LINCOLN COUNTY HEALTH DEPARTMENT
ENVIRONMENTAL HEALTH
WASTEWATER TREATMENT AND DISPOSAL SYSTEM PERMIT

LOT LAYOUT

LOT 16E, UPHAM BEACH
COS 4902
SECTION 32, TWP. 29 N.,
R. 33 W., P.M.M.
FOR: MELISSA AND STEVE FERNALD
DATE: MAY 2023

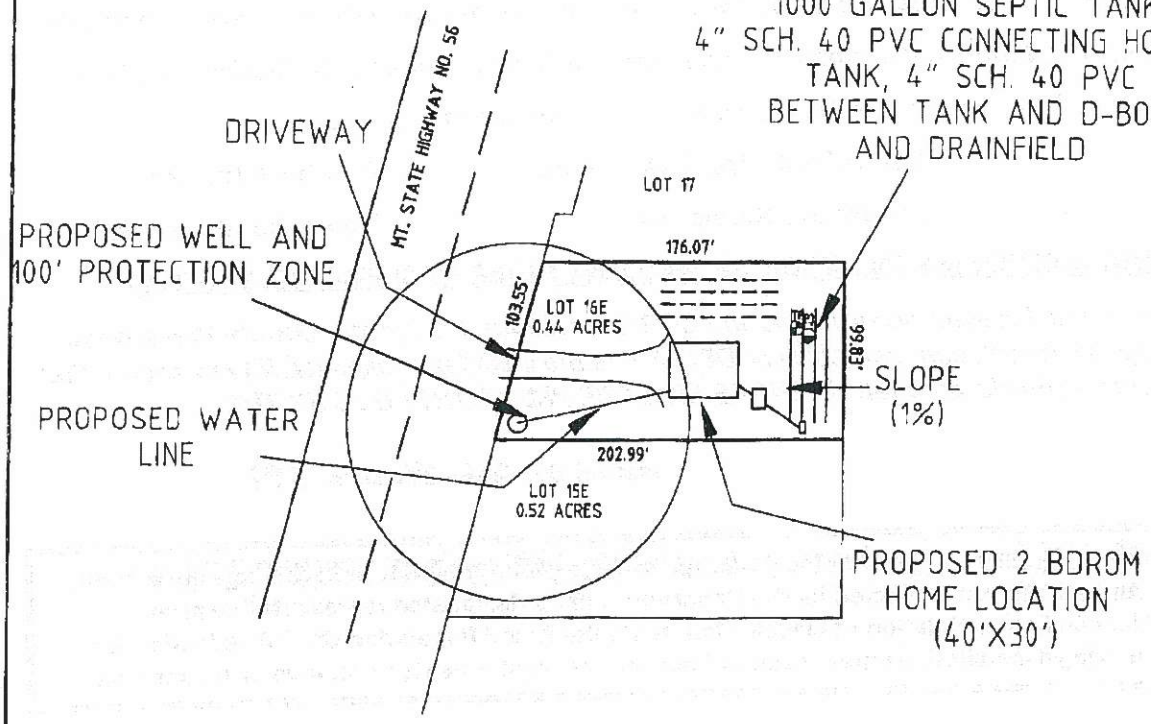
64

- PROPOSED PRIMARY DRAINFIELD 4-~~80'~~64' x 24" TRENCHES 7' APART
- PROPOSED REPLACEMENT DRAINFIELD 4 70' x 24" TRENCHES 7' APART
- TP — SOIL PROFILE
- PT — PERCOLATION SITE
- W — WELL SITE (PROPOSED)
- SLOPE
